**From:** Brandy McMahon <bcmcmahon@trpa.gov>  
**Sent:** 5/3/2024 2:25:39 PM  
**To:** Graham St. Michel <gstsmichel@trpa.gov>  
**Subject:** FW: TRPA Case ERSP2023-0701  
**Attachments:** [image001.jpg](#), [32 Moana Cir - Findings 2024.01.10.pdf](#), [32 Moana Circle - revised TRPA Plan Set 2024.01.10.pdf](#)

**Re: Figone Garage & ADU**  
**APN: 098-191-018**  
32 Moana Circle  
Tahoma, California 96142  
Placer County

# Figone ADU & Garage

**A3.3**

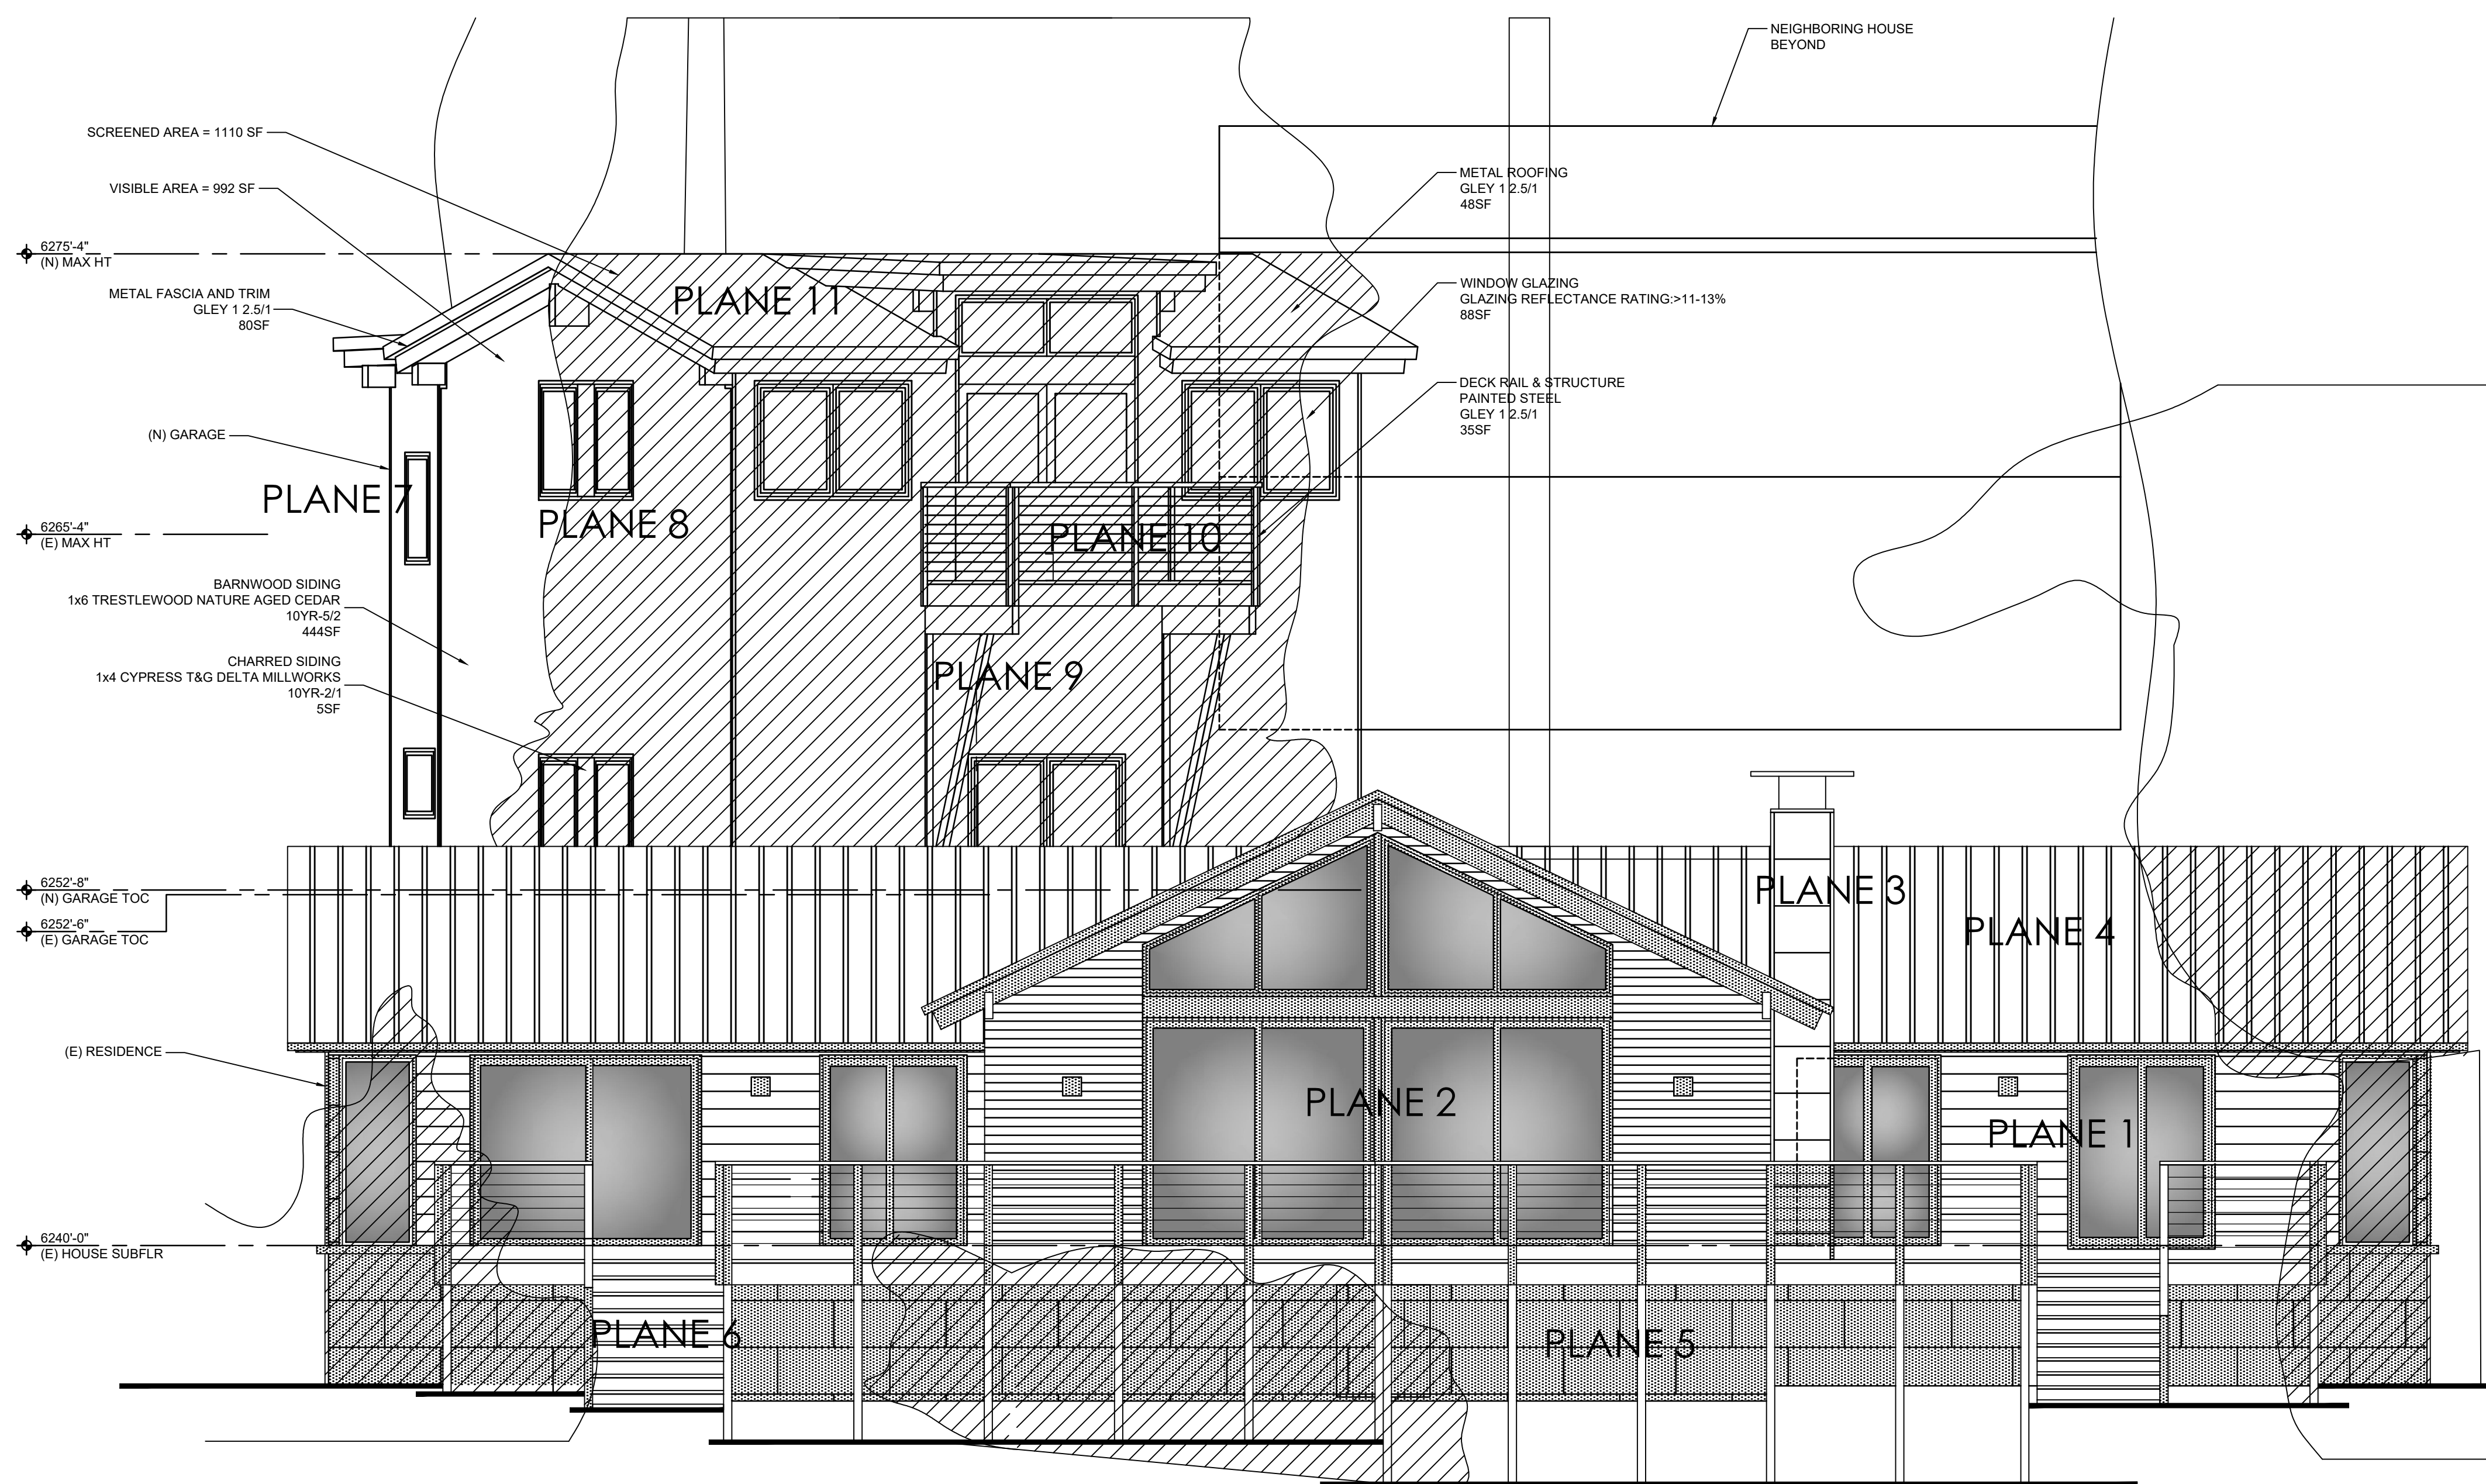
1. The note on A3.3 that reads "THE VISUAL ASSESSMENT FOR THE PROPOSED PROJECT WAS EVALUATED AS A PROJECT AREA TO INCLUDE APN: 094-191-018" needs to be revised to reference APN: 098-191-018 (the subject site). *I will condition this change be made in the permit.*

2. I still need a BMP plan for the entire site, not just the proposed ADU/garage.
3. A driveway with a 12.5% slope is proposed. Please address the attached finding and email me a copy.
4. In one of the public comment letters, it says "the photos for the scenic assessment are from 2021. The landscape has changed a bit, including the removal of a large tree in front of the main house, which could perhaps affect the scenic assessment." TRPA approved a tree removal permit (ref. TREE2022-0984). Please confirm that the tree that was removed is not included in the scenic assessment.

1. I have revised sheet A3.3 with the correct APN.
2. The BMP plan for the entire site is shown on page C1.1.
3. I recalculated the slope of the driveway - the 12.5% slope calculation was incorrect. I have recalculated the slope of the driveway to be 10% based on the proposed driveway. I have addressed the finding and included it in this email.
4. I have confirmed the tree was removed and revised the scenic assessment accordingly. See sheet A3.3.
